LOCAL HISTORIC DISTRICT: Wilmore

PROPERTY ADDRESS: 1822 Wickford Place, Lot 2

SUMMARY OF REQUEST: New Construction

HDC-2019-00364

SOFFIT DETAIL – UPDATED OPEN TAIL

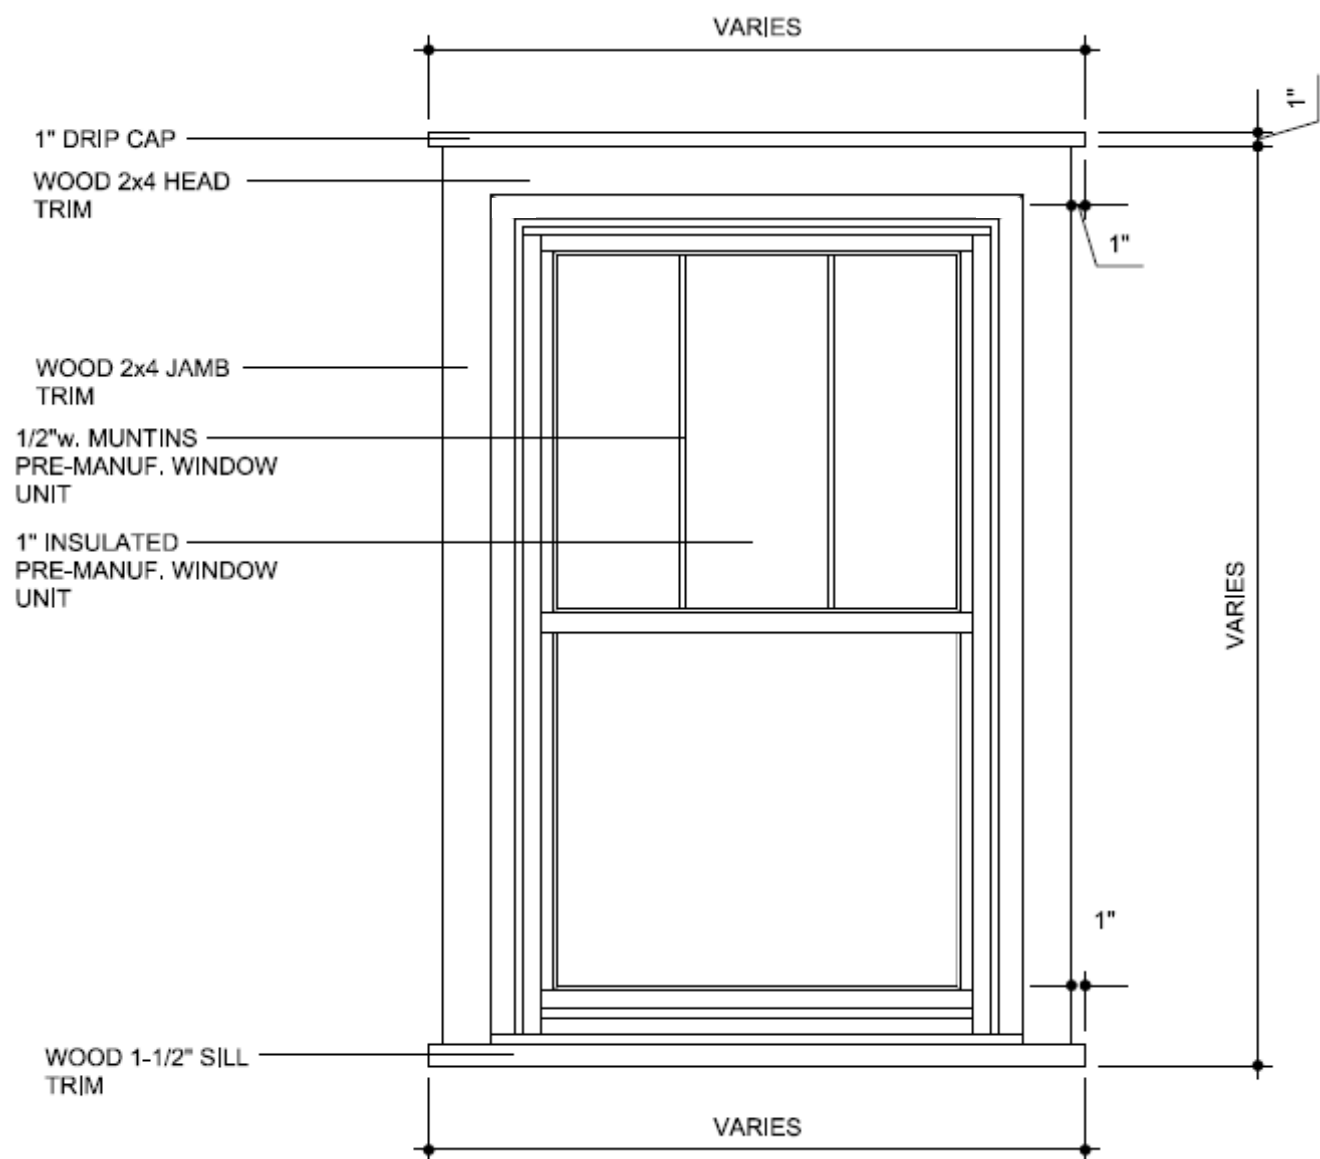
- *Miratek installed on columns, corners, fascia*
- *Windows– Take brick casing off, 4" wide non- tapered trim with 7/8 inch putty glaze*
- *Roof overhang extended to 24 inches at right angle to siding*
- *¾ individual V-groove bead board soffit*
- *2X8" barge rafters with bed mold installed base*

3. Roof overhang not changed per condition.
4. V-groove bead board soffit not noted on plans.
5. Staff concern over Elevation Notes on A3.1 that German-style siding, door, and window styles to be selected by owner.
6. The project is not incongruous with the district and meets guidelines for New Construction.
7. Staff Recommends reinstating the **Approval with Conditions with Staff to work with applicant**, per 10.4.1 of the Rules for Procedure.
8. If requested by a Commission member, or if an interested party has signed up to speak in opposition, then the HDC shall open the application for a full hearing.
